Access Compliance Report

Public Rights-of-Way

Intersection ID: 4012	Main Street: CLINGMAN_LN	Cross Street: WRANGELL_LN	Location: NE
ADA ID: A10A9BF9A509	Ramp Type: BlendTrans1	Initial Pass/Fail: Fail	Overall Compliance: No
			Severity Score: 21.25

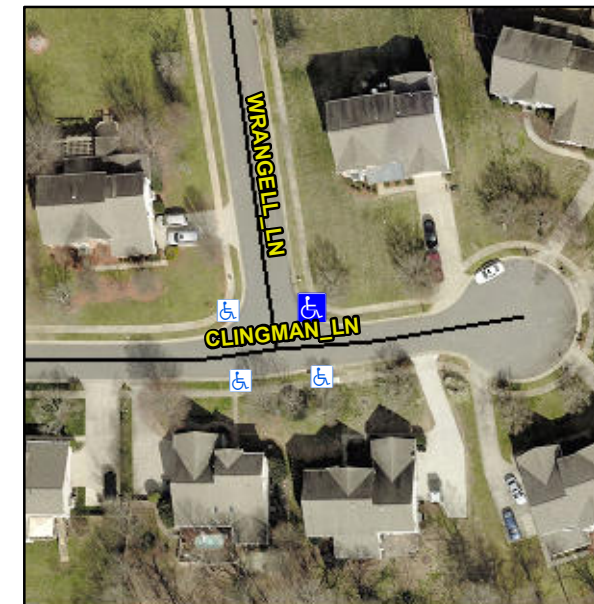
Not Found, R304.5.1, R304.5.3

Compliance	Description	Data	Compliance	Description	Data
N/A	Ramp Length (in)	47.0	Yes	BlendTrans Slope (%)	3.3
No	Ramp Width (in)	39.0	No	BlendTrans XSlope (%)	5.2
N/A	Flare Type LT	N/A	N/A	Flare Type RT	N/A
N/A	Flare Slope LT (%)	N/A	N/A	Flare Slope RT (%)	N/A
N/A	Flare Traversable LT?	N/A	N/A	Flare Traversable RT?	N/A
N/A	Landing Length (in)	N/A	N/A	DWS Provided?	N/A
N/A	Landing Width (in)	N/A	N/A	DWS Contrast?	N/A
N/A	Landing Slope (%)	N/A	N/A	DWS Length (in)	N/A
N/A	Landing X Slope (%)	N/A	N/A	DWS Full Width?	N/A
N/A	Landing Curb? (Y/N)	N/A	N/A	DWS Offset (in)	N/A
N/A	Shared Landing?	N/A			
N/A	Gutter Ponding?	N/A	N/A	Gutter Slope (%)	N/A
N/A	Gutter Lip Ht (in)	N/A	N/A	Gutter X Slope (%)	N/A
N/A	Painted X Walk1?	No	N/A	Painted X Walk2?	No
	X Walk 1 Direction	To W		X Walk 2 Direction	To S
	X Walk 1 Width (in)	N/A		X Walk 2 Width (in)	N/A
	X Walk 1 Slope (%)	1.8		X Walk 2 Slope (%)	3.9
	X Walk 1 X Slope (%)	5.6		X Walk 2 X Slope (%)	1.3

Remove & Replace Curb Ramp With Two New Directional Ramps or Equivalent.
